Board of County Commissioners

After-the-Fact Shoreline Alteration/Dredge and Fill Permit Application SADF-20-03-008

Applicants: John and Jean Amm

July 28, 2020

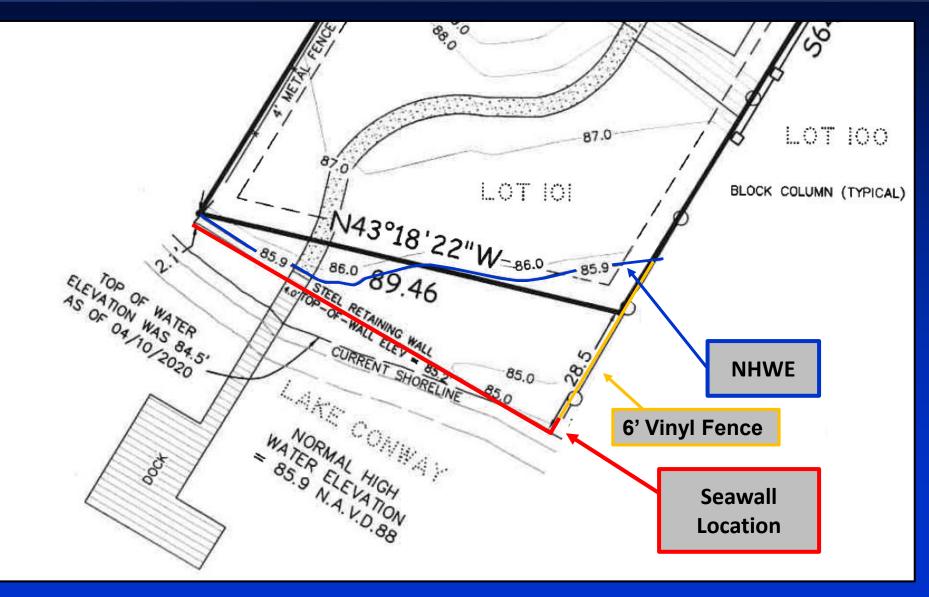
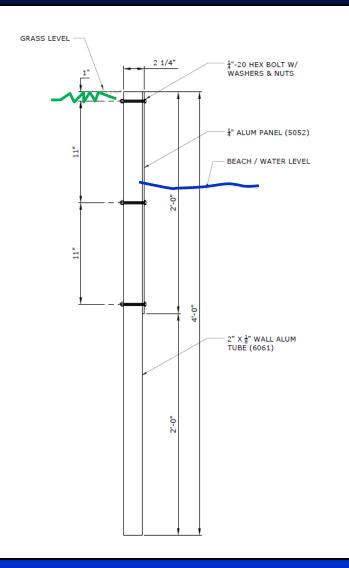
- Applicants installed a new seawall without authorization in early 2020.
 - Photos taken prior to installation of the seawall show erosion was occurring.
- Portion of vinyl privacy fence installed in 2018 extends below NHWE.
 - SADF permit is also needed for that portion of the wall.
- Due to installation of a weir in the 1960s, lake levels were lowered.
 - Subsequently lands below the NHWE that were previously wet became dry, including areas around the seawall and a portion of the privacy fence.
 - Division of State Lands verified that land between NHWE and shoreline where the seawall and fence are located would not be considered sovereignty submerged lands.
- Neighboring property to the north has an existing seawall and to the south is an HOA lot with boat ramp.

- Based on prior Board direction, riprap and plantings are generally required for new seawalls and replacement seawalls.
- In this case, riprap is not being requested due to:
 - The height of the wall (~12") is only as high as the existing adjacent sod.
 - The existing wall will not redirect wave energy or adversely affect adjacent properties to the same extent a higher wall would.
 - The required minimum riprap size is 12" in diameter. The required slope to place riprap is 2:1. This would completely cover the seawall.
- Due to the abundance of the existing submerged vegetation, additional plantings are not being required. A condition has been added prohibiting the removal of native plants outside of the access corridor.

Acceptance of the findings and recommendation of the Environmental Protection Division staff and approval of the Shoreline Alteration/Dredge and Fill Permit SADF-20-03-008 for John and Jean Amm, subject to the conditions listed in the staff report. District 3
